Turbocharger Mounting Hardware Replacement

Service Category Service Department

Section Function Group 255

Model Years	Models
2023-2024	AN, GR, PI, TE

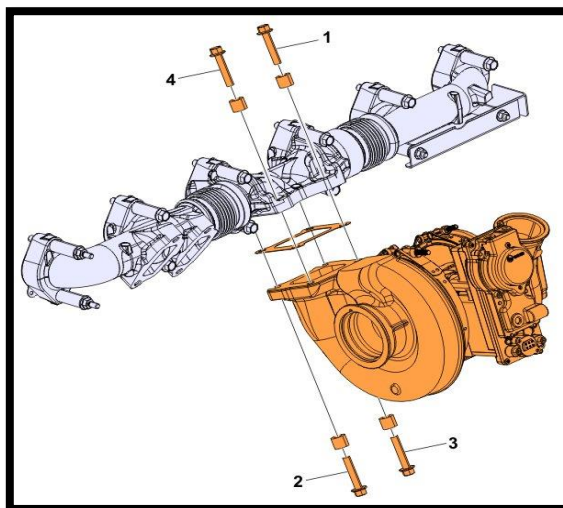
Turbocharger Mounting Hardware must be torqued following the sequence shown below.

Turbocharger, nut	1.	Tightening sequence: 1-4
		20 ±4 Nm (15 ±3 lb _r ·ft)
	2.	Tightening sequence: 1-4
		48 ±8 Nm (35 ±6 lb _r ·ft)
